ARMY AVIATION TEST BOARD FORT RUCKER ALA
INSTALLATION OF ATTITUDE AND DIRECTIONAL INDICATORS IN OH-23D H--ETC(U)
SEP 63

SUBJECT: Report of Test, USATECOM Project No. 4-3-3850-01-G,
Installation of Attitude and Directional Indicators in
OH-23D Helicopters

INSTALLATION OF ATTITUDE AND DIRECTIONAL INSTRUMENTS
IN OH-23D HELICOPTERS

FIGURE I-14

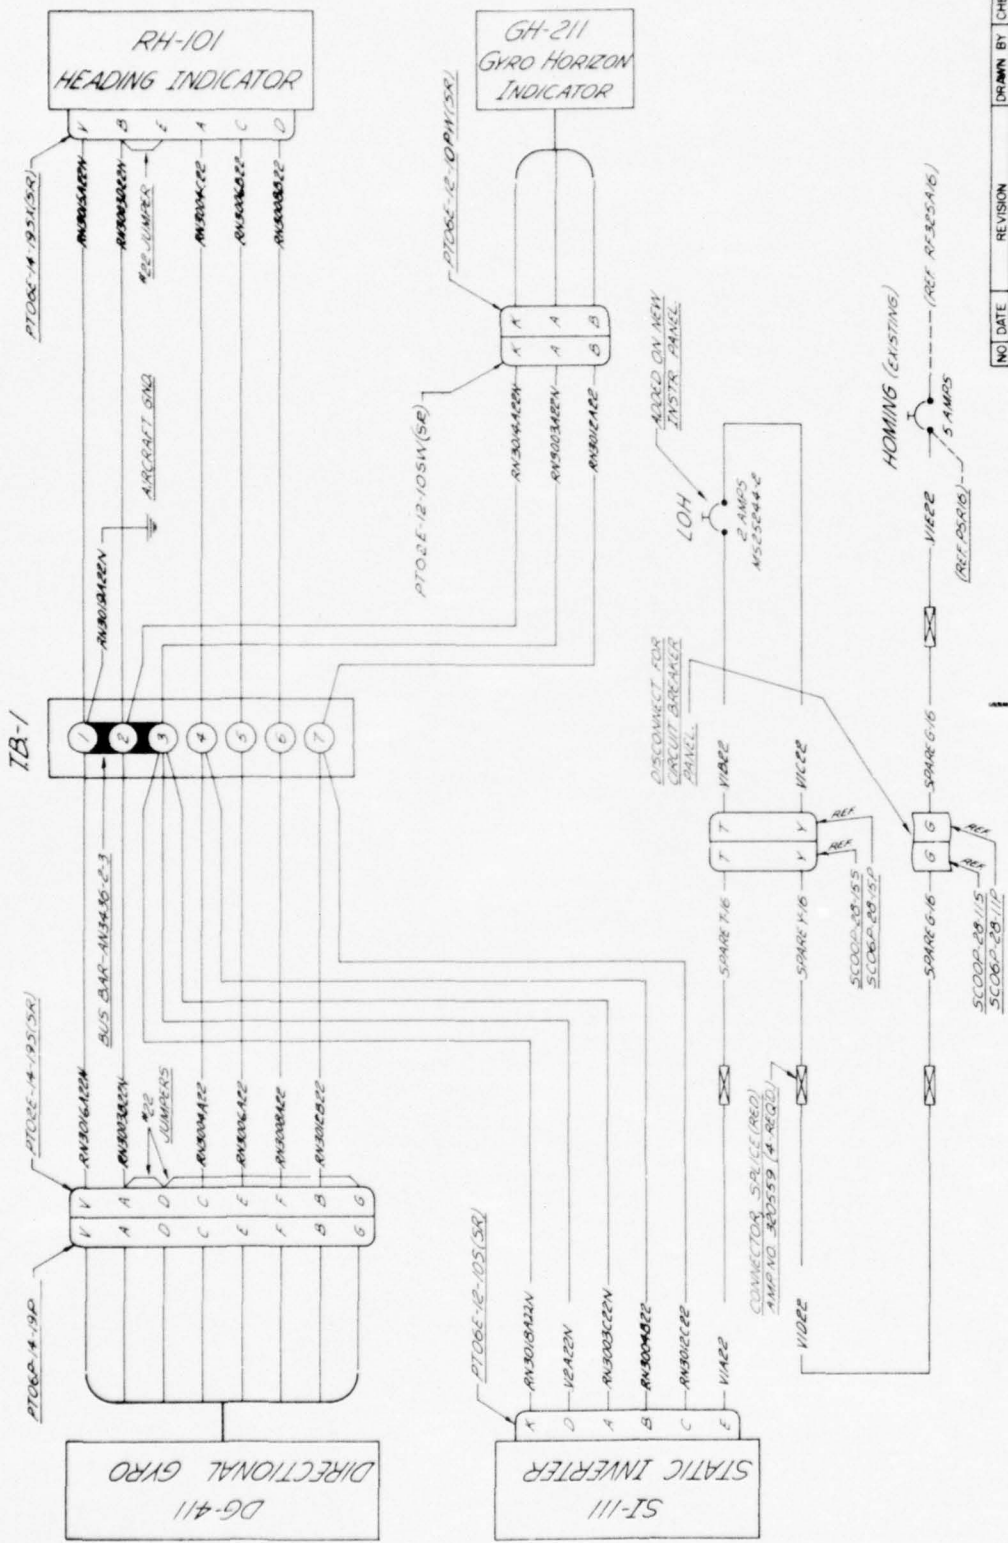
(b) Install the magneto switch on the instrument panel using existing mounting hardware. (See Figure I-14.)

(c) Install the FM homing switch and FM squelch switch on the instrument panel, using the hardware supplied with the switches. (See Figure I-14.)

FIG I-17

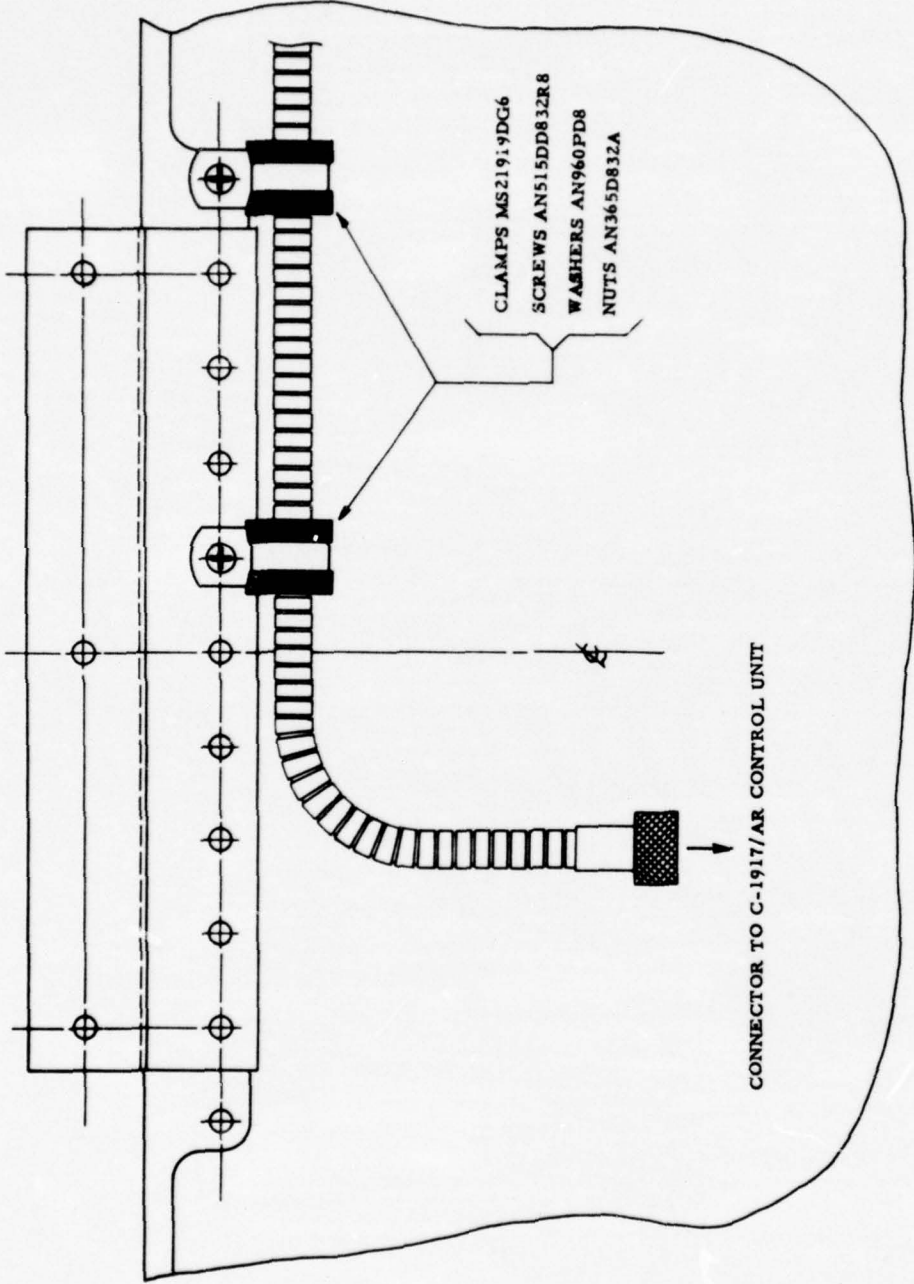
(c) Secure the mechanical tuning linkage to the top of the control pedestal as follows: (See Figure I-17.)

1. Locate the rivet line on top of control pedestal and remove the first and fifth rivets to the right of centerline. (See Figure I-17.) Enlarge the two vacated rivet holes to a 0.166 inch diameter using a No. 19 drill.

2. Using the two holes enlarged in Step 1. above, secure mechanical linkage using two clamps (MS21919DG6), two screws (AN515DD832R8), four washers (AN960PD8), and two nuts (AN365D832A). (See Figure I-17.)
